Amendments to the Drawings

Application No. 10/748,755
Amdt. dated December 11, 2006
Reply to Office Action dated August 10, 2006

Application No. 10/748,755
Office Action dated Dec. 11, 2006
Reply to Office Action dated Aug. 10, 2006
Annotated Sheet Showing Changes

FIG. 1

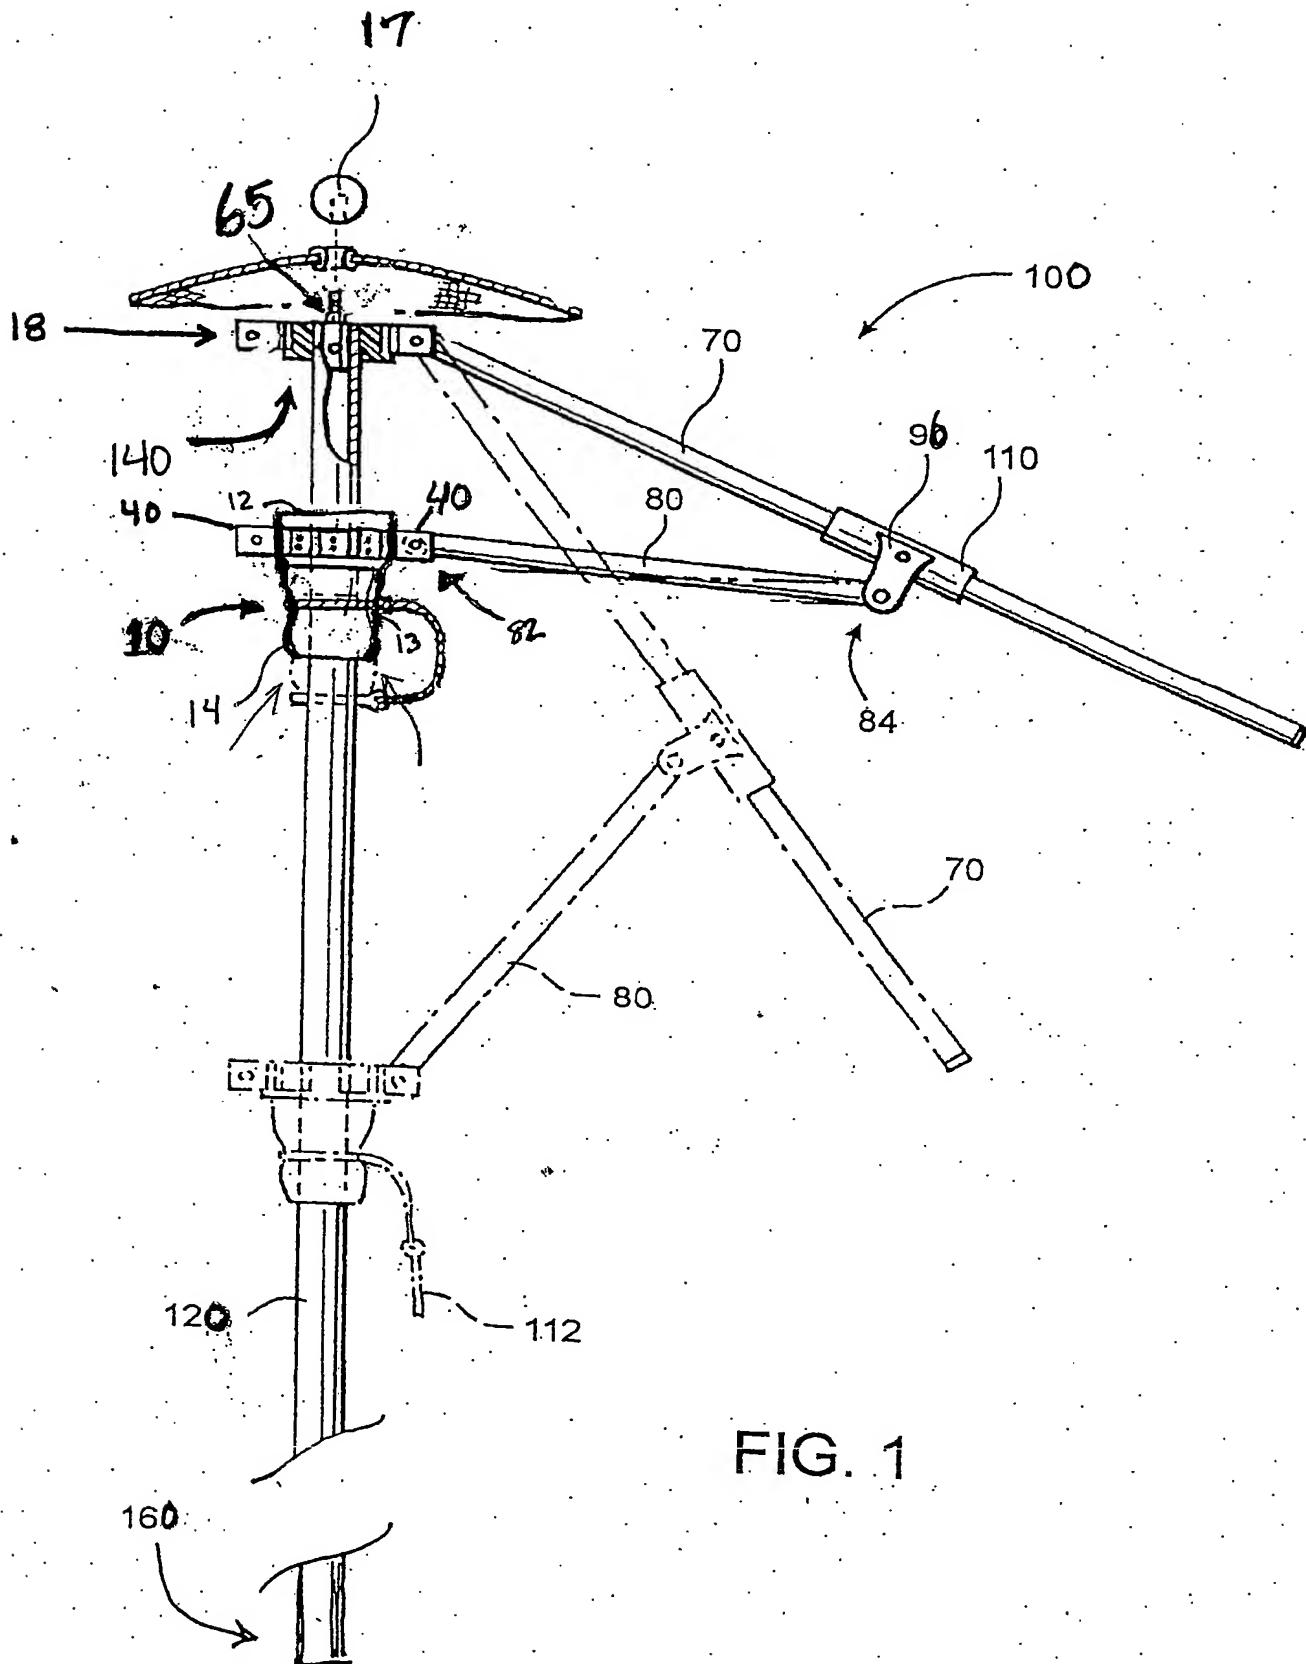
Further, as set forth above, the drawings are objected to as failing to comply with 37 C.F.R. §1.84(m) because the solid black shading is not permitted. Accordingly, six (6) Replacement Sheets are attached hereto which more clearly depict Applicant's novel invention without any solid black shading.
